PARK CITY MUNICIPAL CORPORATION
ADMINISTRATIVE PUBLIC MEETING MINUTES
PLANNING DEPARTMENT
<https://us02web.zoom.us/j/88167820277>
June 26, 2025

3995 Quinns Drive – Administrative Conditional Use Permit – PL-25-06461 –
The Applicant Proposes an Administrative Conditional Use Permit for Phase III of the Studio Crossing Master Planned Development, to Develop 50 Condominium Townhome Units in the Community Transition Zoning District, Regional Commercial Overlay, Sensitive Land Overlay, and the Entry Corridor Protection Overlay.

36 Prospect Avenue – Historic District Design Review – PL-24-06186 – The Applicant Proposes to Construct a Basement Addition on a Landmark Historic Structure and a Detached Garage and Accessory Building in the Historic Residential - 1 Zoning District.

2392 Holiday Ranch Loop Road – Administrative Conditional Use Permit – PL-25-06549 – The Applicant Proposes to Construct a 204-Square-Foot Shade Structure at the Creekside Park in the Urban Park Zoning District.

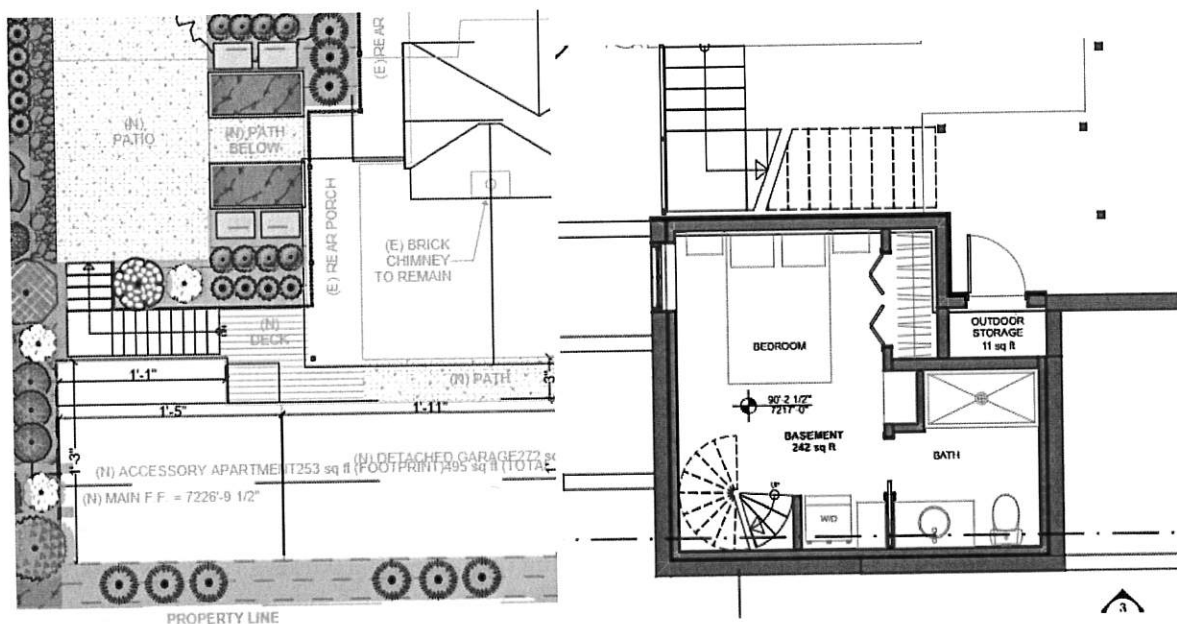
Though the Conditional Use Permit clarifies that they cannot build an Accessory Apartment, Exhibit B still shows an apartment layout with bedroom, kitchen, and bathroom on pages 11 and 12, and it is labeled "Accessory Apartment" on page 8 (see below). Parking on Prospect Avenue has always been a challenge – the road is extremely steep and only wide enough for one car to drive at a time. Many properties have inadequate parking and tenants must jockey for the public parking spots. I don't see driveway distance on the documents, but all descriptions of the driveway suggest it's too short to tandem park. I am supportive of the applicant's attempt to provide an accessory apartment that, if legal, would be required by code to host long-term renters only -- although the house as it currently stands has more bedrooms than the proposed renovation with accessory apartment, so I'm more supportive of keeping it closer to its current state. Nonetheless, by my understanding, the proposed addition does not meet the parking requirements. 36 Prospect currently has off-street parallel parking for two vehicles in front of the house.
